Section 4.55(2) Modification Application to DA35/2024

1 Gatacre and 1-5 Allison Avenues, Lane
Cove

APRIL 2025

Figure 2: Approved Basement 2 Design
Source: PBD Architects

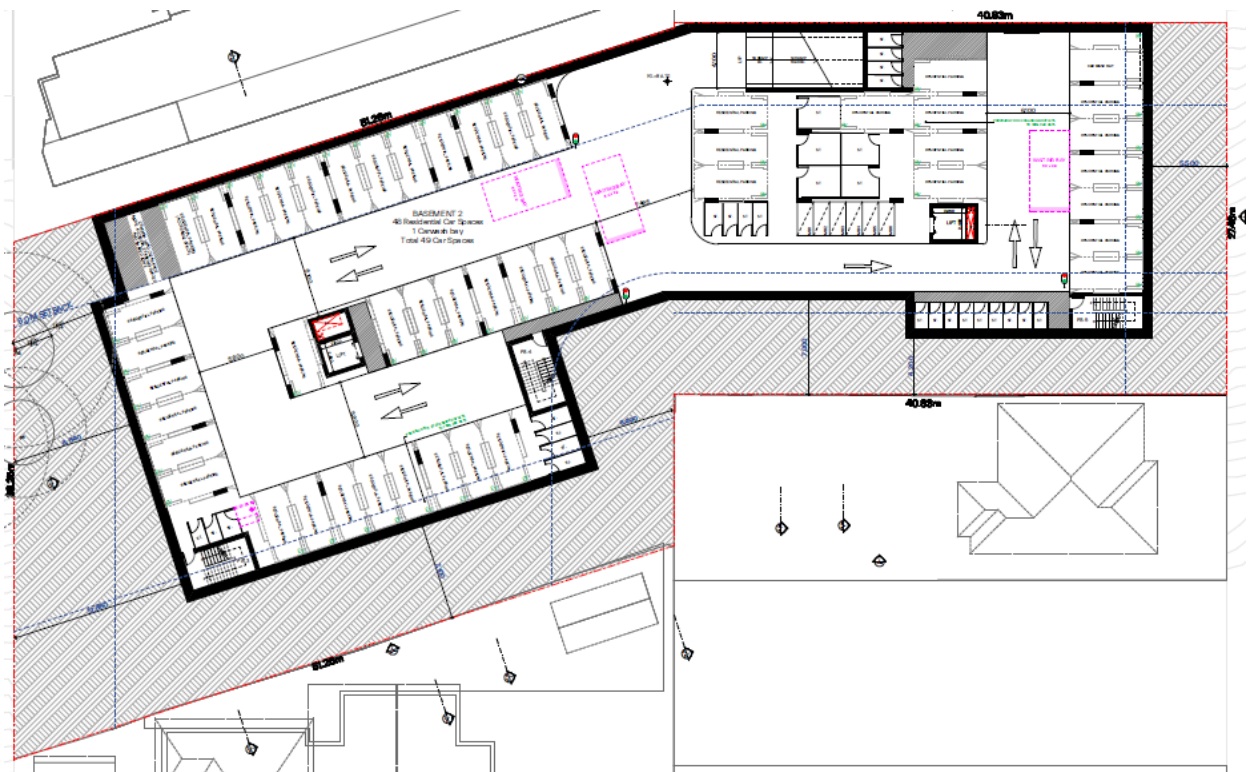
- Change 1 - 2 accessible parking bays have been moved from B1 to B2.

A comparison between the approved and proposed design of the Basement 2 is demonstrated in Figure 2 and Figure 3.

Figure 4: Approved Basement 1 Design
Source: PBD Architects

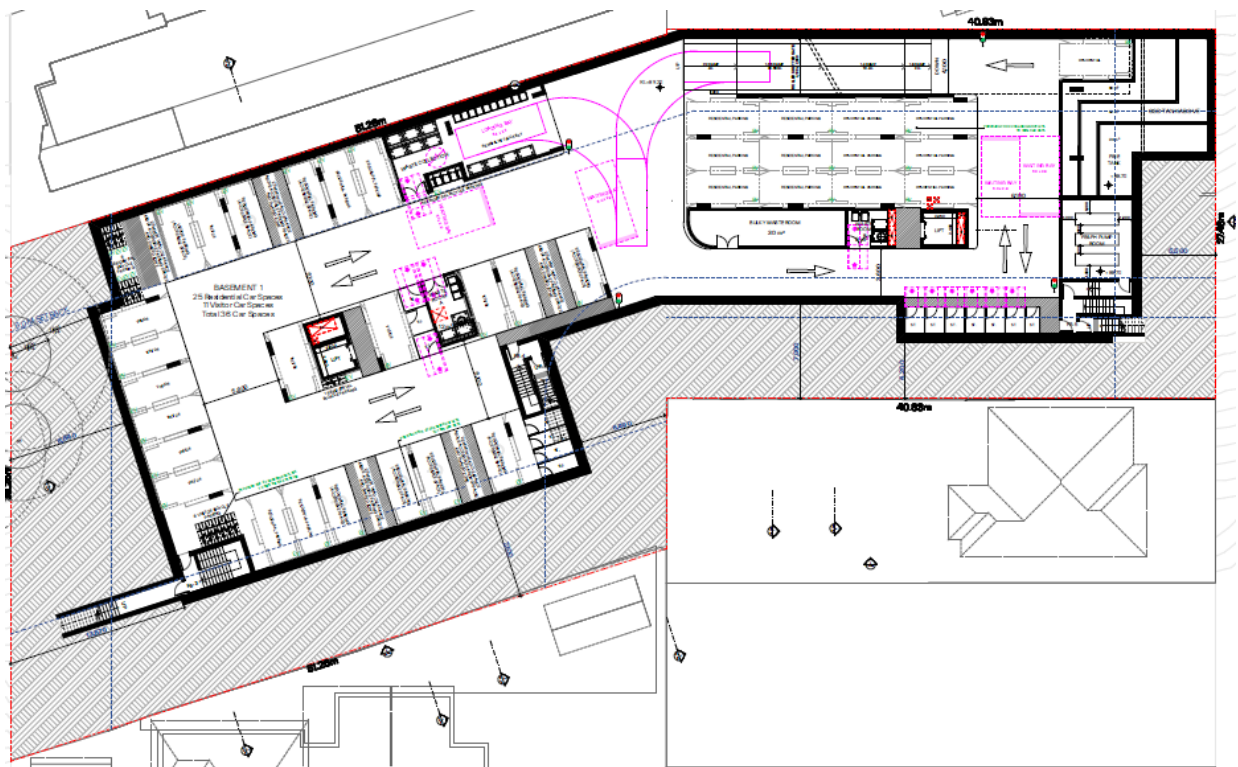
- Change 2 - Basement 1 slab RL lowered by 150mm to increase ceiling clearance; and
- Change 3 - Bike racks have been repositioned within the development (no change to quantum provided is proposed).

A comparison between the approved and proposed design of the Basement 1 is demonstrated in Figure 4 and Figure 5.

Figure 7: Proposed Lower Ground Floor Design
Source: PBD Architects

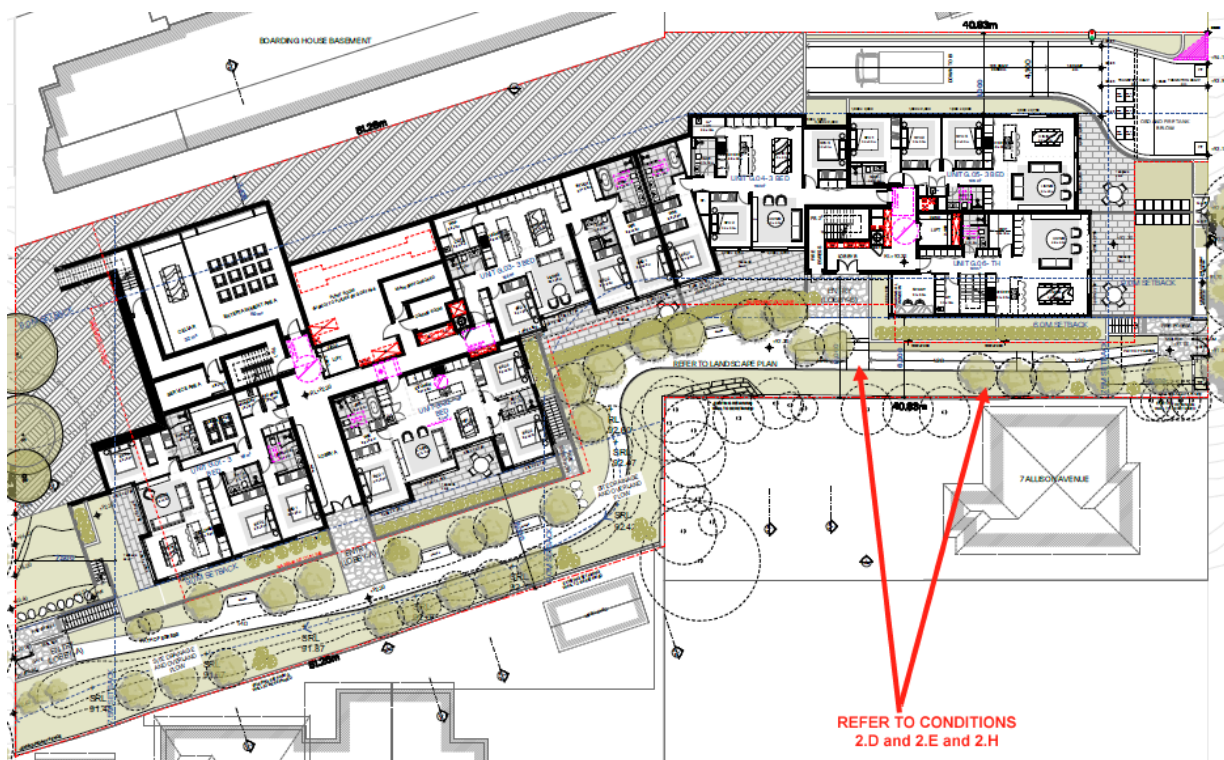
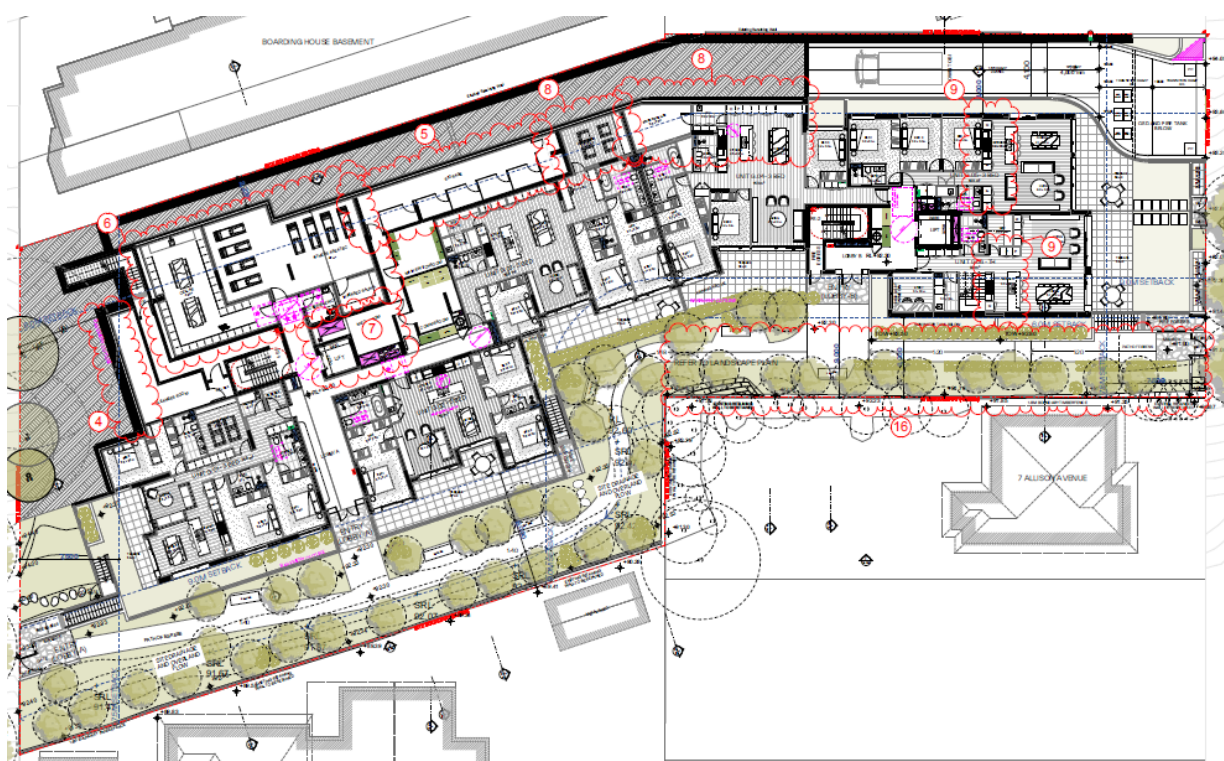
- Change 4 - Shoring wall alignment with basement below (no changes in deep soil from the approved DA);
- Change 5 - A new storage space has been added beneath the approved terraces on the Upper Ground Floor;

- Change 6 - The entertainment area has been reconfigured and transformed into a fitness space, an accessible restroom has been added, and the cellar area has been reconfigured for improved functionality;

- Change 7 - Relocated mechanical fan exhaust to the rooftop;
- Change 8 - Units G03 and G04 have been expanded beneath the approved terraces on the Upper Ground Floor;

- Change 9 - Standardized apartment layouts: Interior layouts have been amended for uniformity across all apartments; and
- Change 16 - Larger trees have been introduced along the boundary with 7 Allison Avenue, boardwalk has been realigned and timber fence to incorporate acoustically treated materials and metal posts to satisfy sub conditions 2 D, E and H.

A comparison between the approved and proposed design of the Lower Ground Floor is demonstrated in Figure 6 and Figure 7.

Figure 9: Proposed Upper Ground Floor Design
Source: PBD Architects

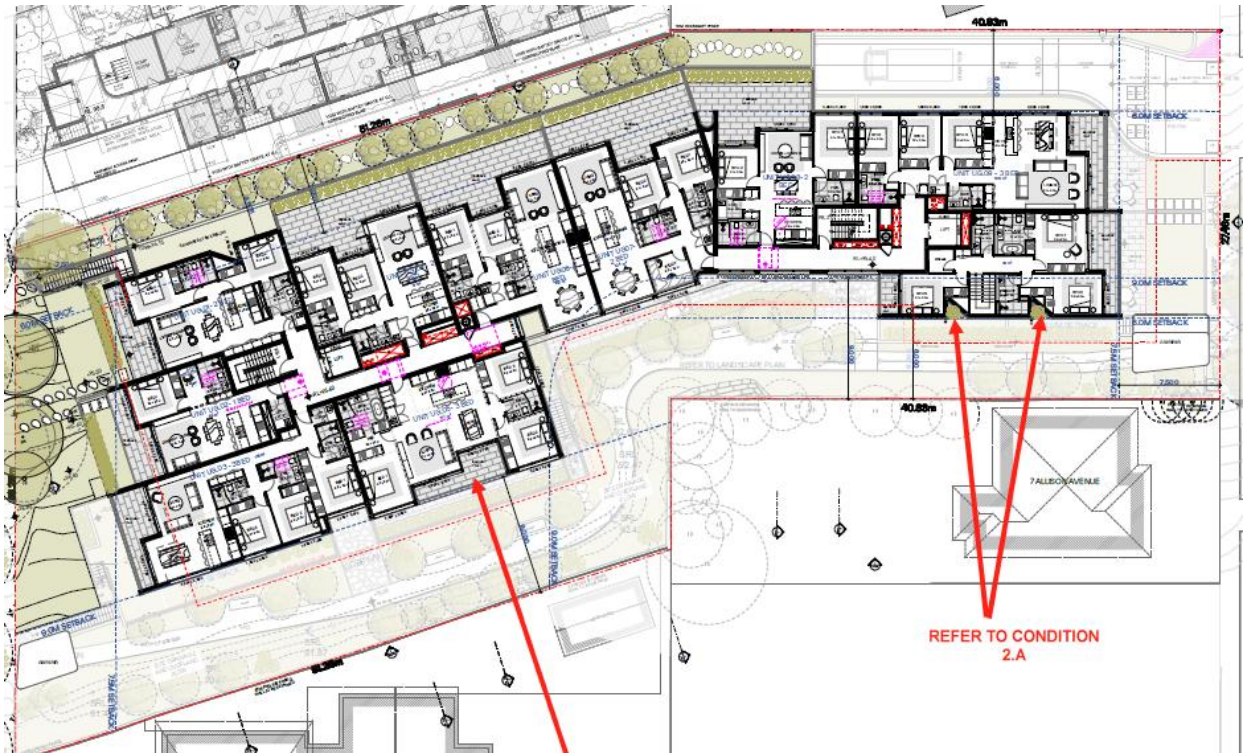
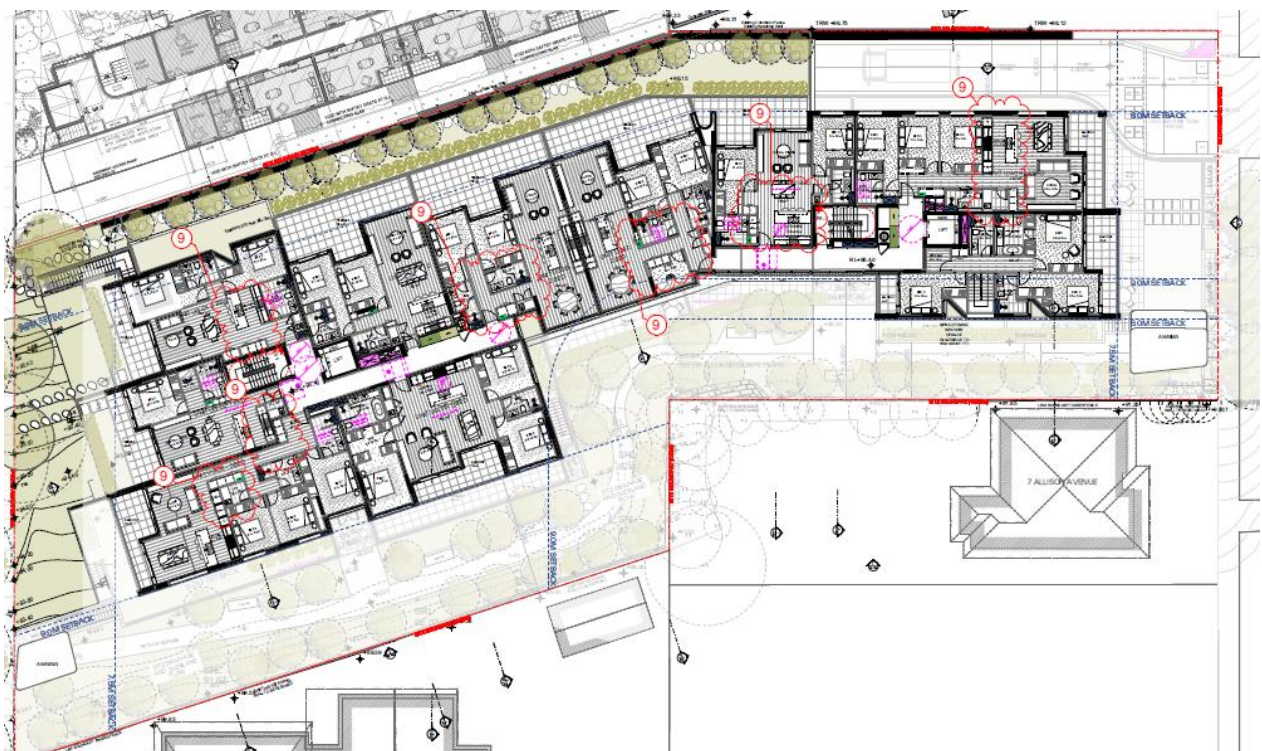
- Change 9 - Standardized apartment layouts: Interior layouts have been amended for uniformity across all apartments.

A comparison between the approved and proposed design of the Upper Ground Floor is demonstrated in Figure 8 and Figure 9.

Figure 11: Proposed Level 1 Design
Source: PBD Architects

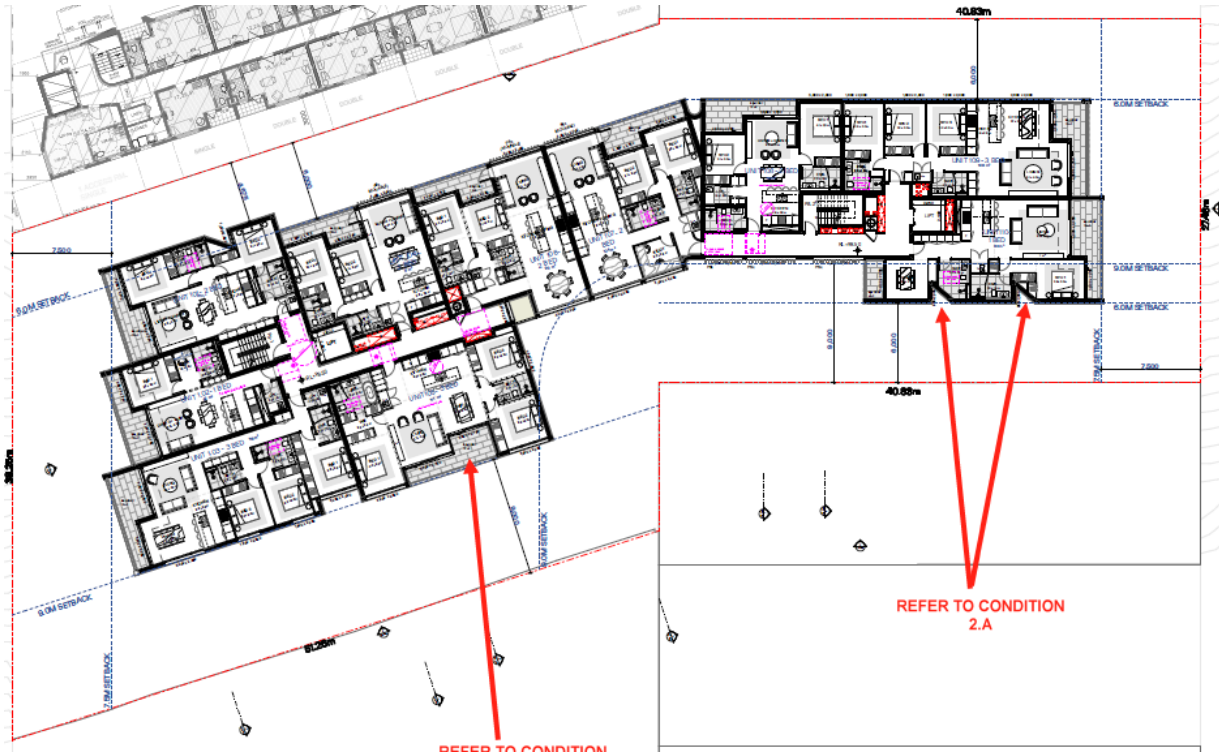
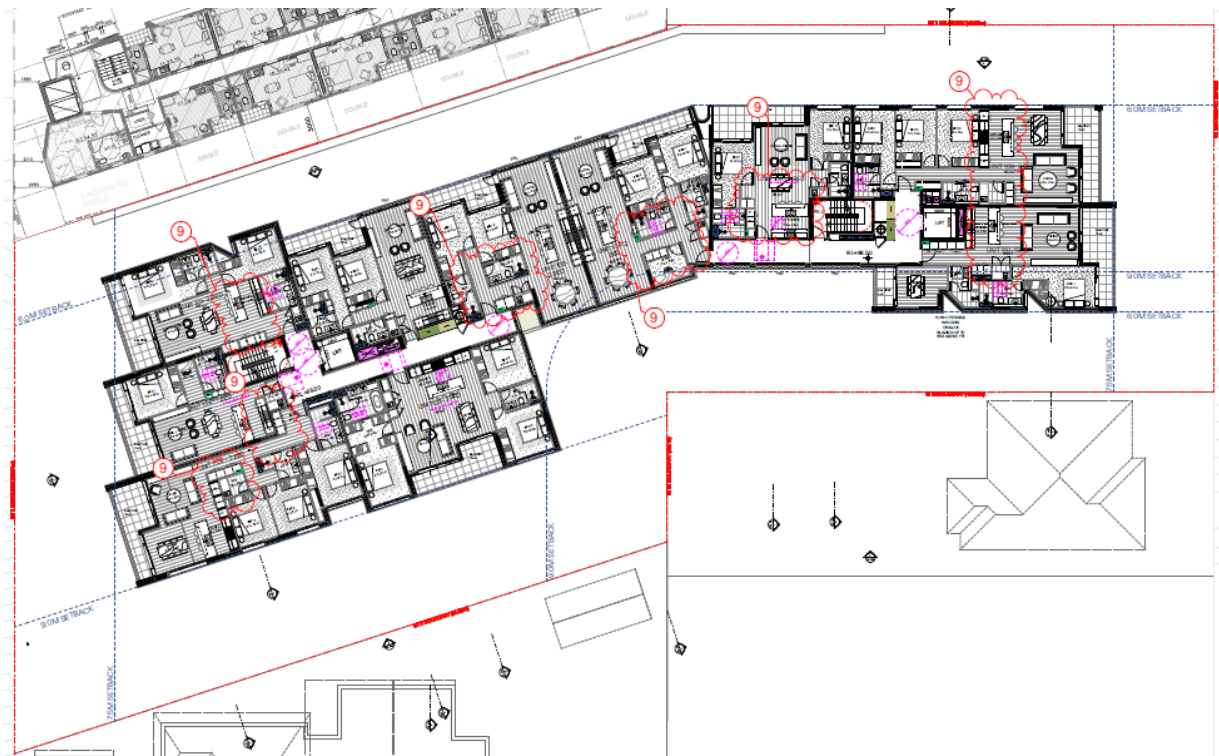
- Change 9 - Standardized apartment layouts: Interior layouts have been amended for uniformity across all apartments.

Figure 13: Proposed Level 2 Design
Source: PBD Architects

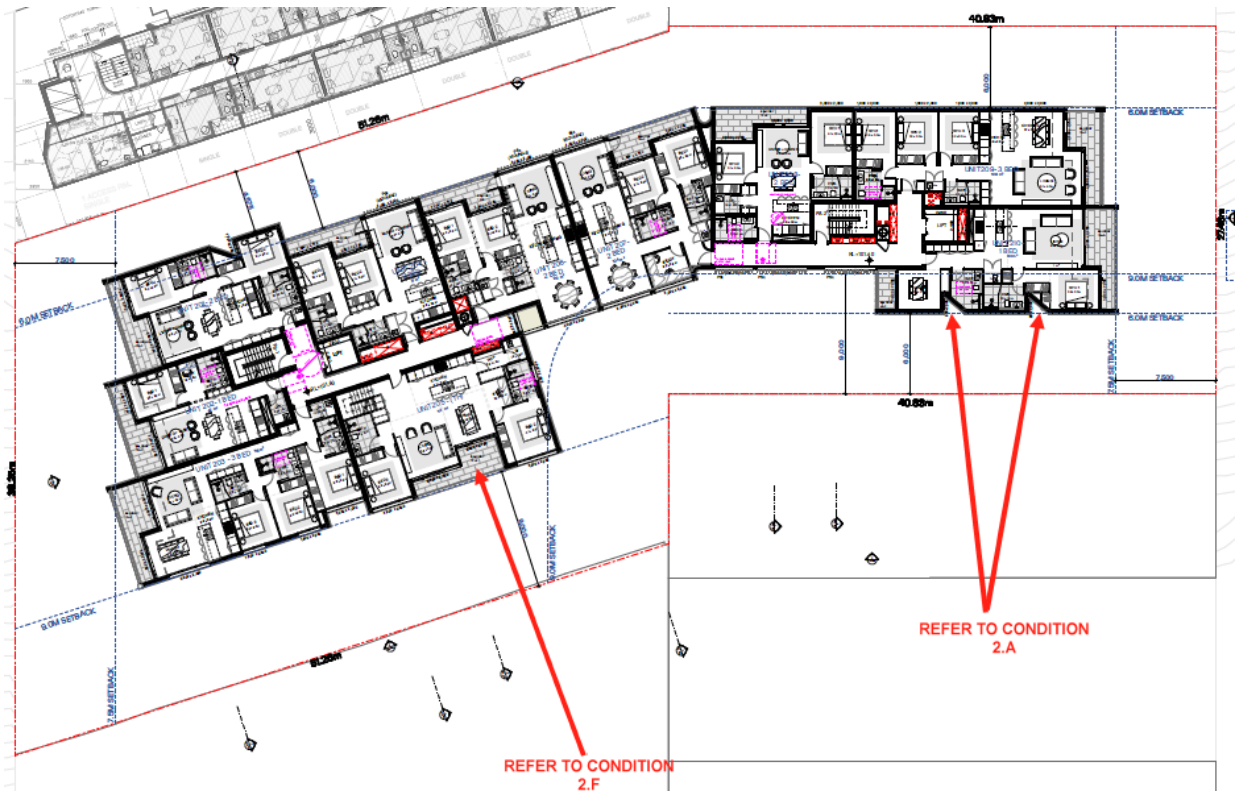
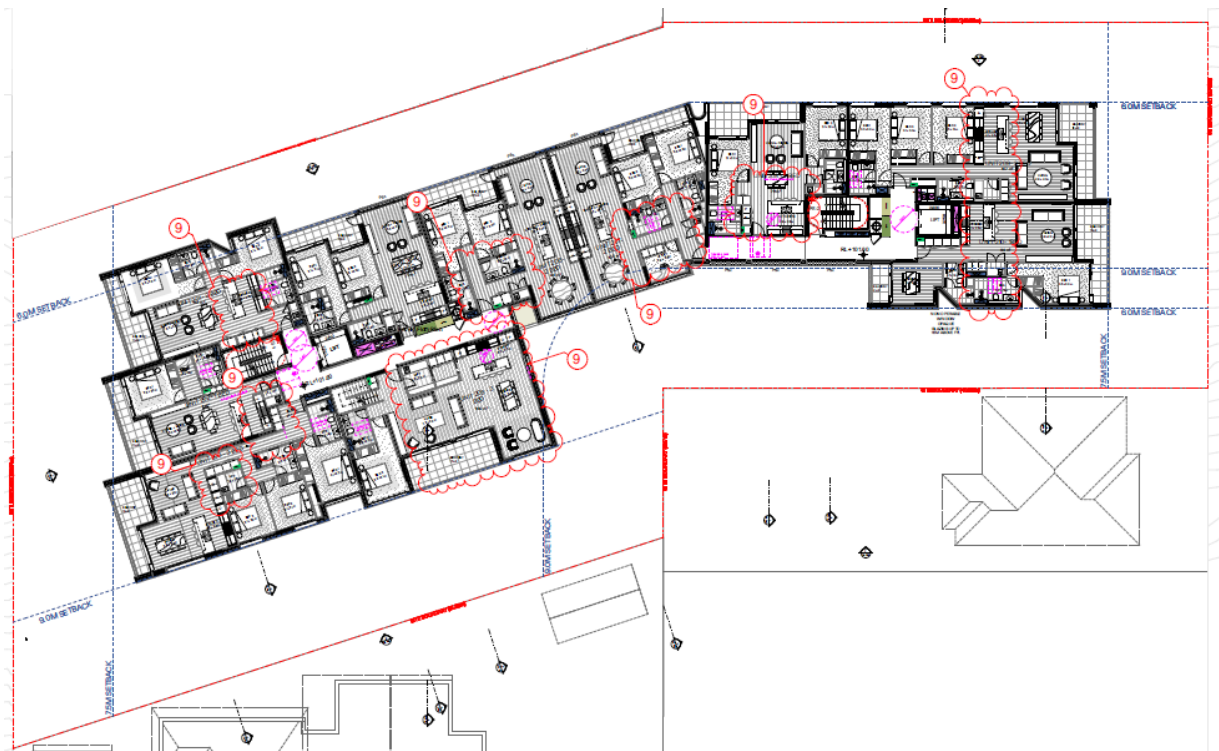
- Change 9 - Standardized apartment layouts: Interior layouts have been amended for uniformity across all apartments.

A comparison between the approved and proposed design of the Level 2 is demonstrated in Figure 12 and Figure 13.
